GMP #79

Subject: Revisions to Experimental Protocol for Puraflo™
Peat Filter Treatment System
Onsite - Product Approval - Puraflo™

Puraflo™ Experimental Protocol

Figure 1

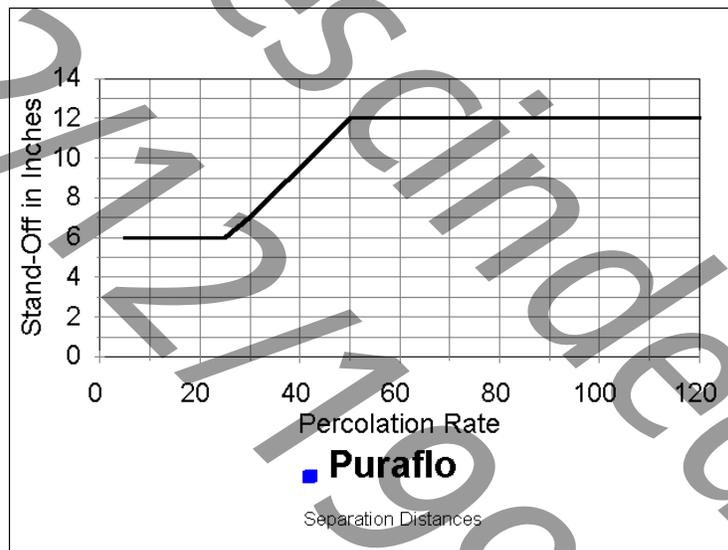
to rock and/or water table requirements contained in the Sewage Handling and Disposal Regulations but does comply with the requirements of Figure 1. **Note:** In accordance with a variances issued on 03/12/96 and 02/04/98, these systems require an available repair area equal to 100% of the original Puraflo™ absorption area (see variance for complete details). Systems meeting these criteria shall be sized in accordance with Bord na Mona's design criteria contained in Tables 2A through 2C.

The stand-off distances to rock and water table for conventional septic systems are proposed for revision. These revisions may affect the stand-off distance for this system. If the proposed revisions are adopted as drafted, the stand-off distance for the Puraflo™ system will be revised to 12 inches in all soil types.
